TECHNICAL INFORMATION

65883

- Subject** ▶ Change of Impact Bolt
- For Models** ▶ HR2020, HR2021, HR2022, HR2440, HR2441, HR2442
- Country** ▶ All countries
- Description** ▶ Material of Impact Bolt has been changed to increase durability.
New Impact Bolt is identical with one for HR2450, HR2451 and HR2452.

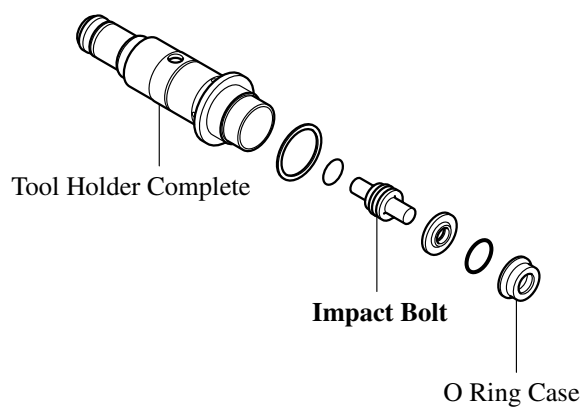
Item No.	Current part		Q'ty	I/C	New part		Q'ty	Note
024	Impact Bolt 324213-2		1	Yes	Impact Bolt 324278-4		1

HR2020: From serial No.25245K (June, 2002)
HR2021: From serial No.6688K (July, 2002)
HR2022: From serial No.45K (June, 2002)
HR2440: From serial No.51569K (June, 2002)
HR2441: From serial No.2024K (June, 2002)
HR2442: To be informed later
